SERVICE BULLETIN

ALL LEGACY MODELS MANUFACTURED BEFORE
THE FOLLOWING VINs: SEDAN 600541
STATION WAGON 900181

12-14-90

SUBJECT: REAR LATERAL LINK NOISE

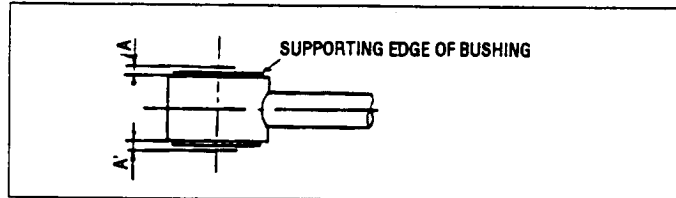
1. Using tool #927820000 Base Tube and suitable push rod tool #899864100, wheel stud, or equivalent, place the lateral link in a press or vise and remove the old bushing.

NOTE: The push pressure should not exceed approximately 1 ton.

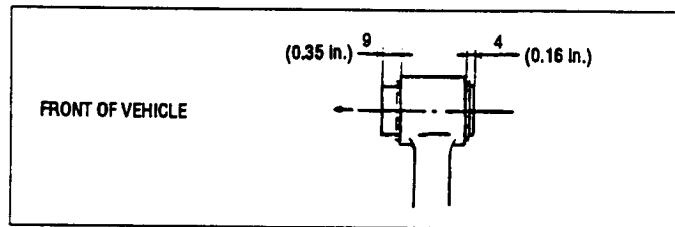
The bushing is to be pressed in so that the protruding portion (edge) is equal on both sides. See diagram below for 4WD.

The bushing is to be pressed in so that the offset (longer side) is towards the front of the vehicle. See diagram below for 2WD.

On all new installed bushings, insure that the rubber supporting edges are protruding from both ends of the lateral link.
